**MODIFICATION TO MAJOR PROJECT MP 09_0200
VEHICLE AND PEDESTRIAN SAFETY PROJECT
AT
THE SYDNEY OPERA HOUSE**

ENVIRONMENTAL ASSESSMENT

Prepared on behalf of
The Sydney Opera House Trust
November 2012

Figure 1: location of pedestrian cross tunnel at basement level.

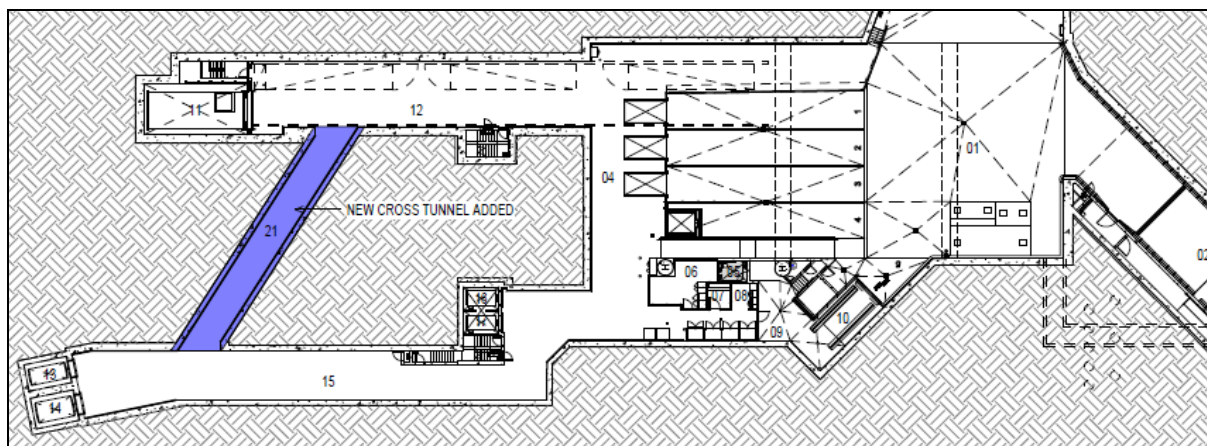
It is proposed to incorporate a new pedestrian tunnel linking the Opera Theatre Tunnel and Concert Hall Corridor. Refer to **Figure 1** below. The new tunnel is at level B4, around 9 metres below ground level. It would be around 22m long, 3.2m wide and have a varying height of 2.4 to 4.4m.

The additional tunnel is required to improve construction methodology: to allow the tunnelling equipment to cross from the Opera Theatre Corridor to the Concert Hall Corridor, improving and thereby reducing the length of the construction program.

The long-term benefits of maintaining the cross-tunnel post excavation include improvements to safety, by offering an alternate path of egress out of each of the corridors; and improvements to circulation and therefore the efficiency of back-of-house functions particularly during bump in and bump out of events.

Figure 3: Extract from Plans showing proposed Gate House, with approved and existing Gate Houses outlined.

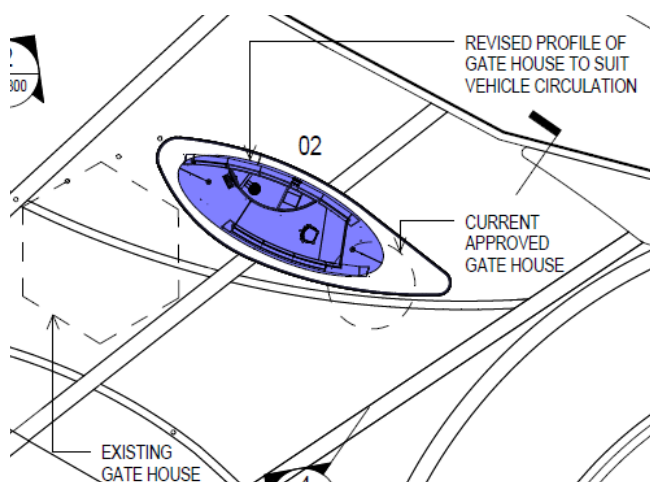
It is proposed to change the design of the Gate House and to slightly amend its location. Specifically, it is proposed to:

- Amend the scale and shape of the Gate House;
- Relocate the Gate House slightly to the north;
- Amend the external appearance and material selection.

The functional needs of the Gate House including security and amenity needs have necessitated that its size be increased from that originally proposed. An elliptical shape is proposed, that will have the same width of the approved circular Gate House, and still remains significantly smaller than the existing Gate House to be demolished. **Figures 3 and 4** below provide a comparison between the existing, approved and proposed Gate Houses.

The elliptical shape and the slightly modified location are also a result of detailed testing of vehicle circulation requirements and queuing distances, as well as allowing for maximum security surveillance of the adjoining Forecourt area. Importantly, the modified scheme allows a semi-trailer to stop at the Gate House without obstructing Macquarie Street (as compared to the approved scheme which was limited to a medium rigid truck).

Figure 4: Photomontages comparing existing, approved and proposed Gate House and vehicle entry design.

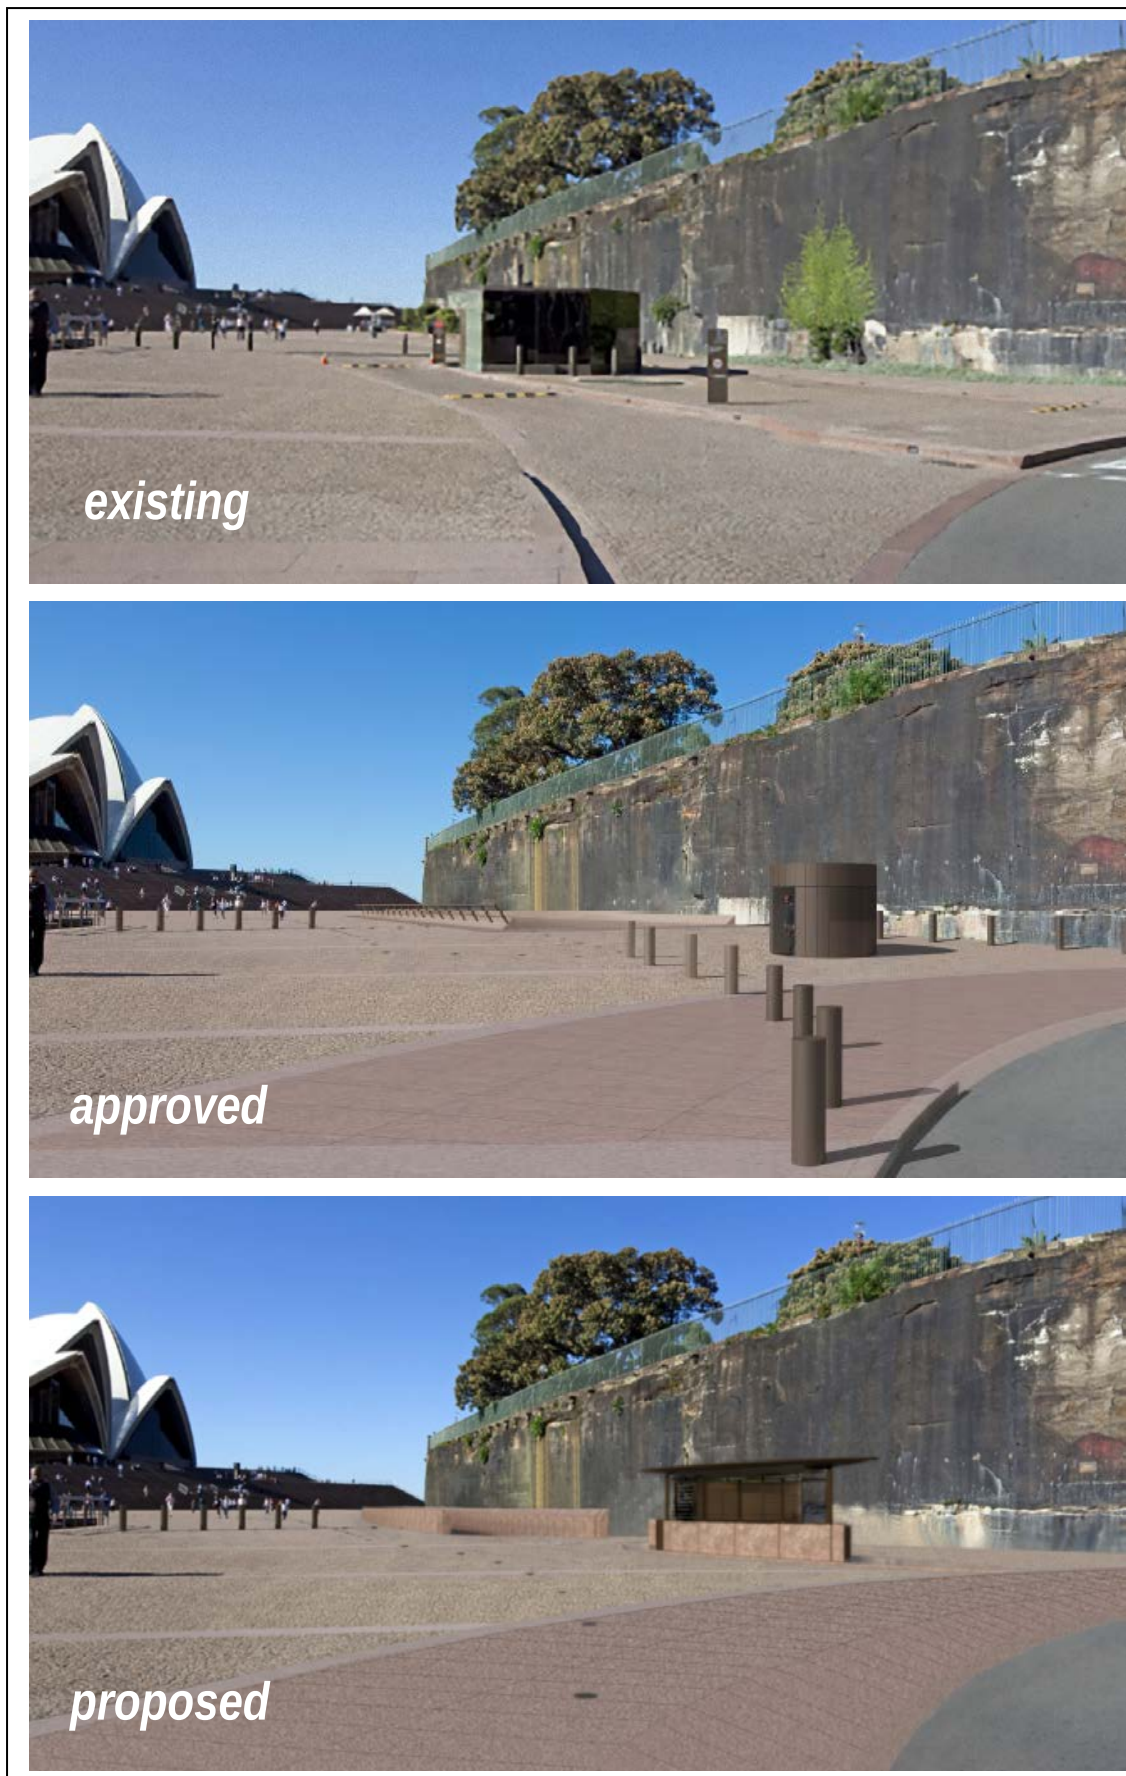
- Amending the western balustrade from 450mm high precast, with metalwork balustrade above, to a 1200mm high precast balustrade.
- And as a result, adjusting the height of the precast on the eastern side of the vehicle entry ramp (against the Tarpeian Wall) to the same height (1200mm above the forecourt); and
- Deleting a section of precast upstand between the ramp portal and the car park vent structure, where the precast sits against the Tarpeian Wall.

The change is depicted in the photomontages at **Figure 4** above.

Due to safety needs, BCA requirements and crowd loading considerations, a change in the design of the balustrade to the western side of the vehicle entry ramp is required. The approved scheme consists of 450mm high pre-cast up-stand with a metalwork balustrade (in keeping with the western edge of the Forecourt), resulting in a 1000mm high balustrade. However, this design does not comply with BCA standards due to the fall below the balustrading exceeding 4.0 metres in height in some locations. In addition, a 1.2m high balustrade is required to comply with the NSW variations to the BCA requirements for Entertainment Venues if the Forecourt is to be used to hold future public events.

To provide a consistent appearance to the vehicle entry ramp, it is proposed to modify the height of the precast cladding on the eastern side of the ramp adjacent to the Tarpeian wall to match the height of the western balustrade. It is proposed to increase the height from 450mm as approved to 1.2 metres to match the increased balustrade height described above.
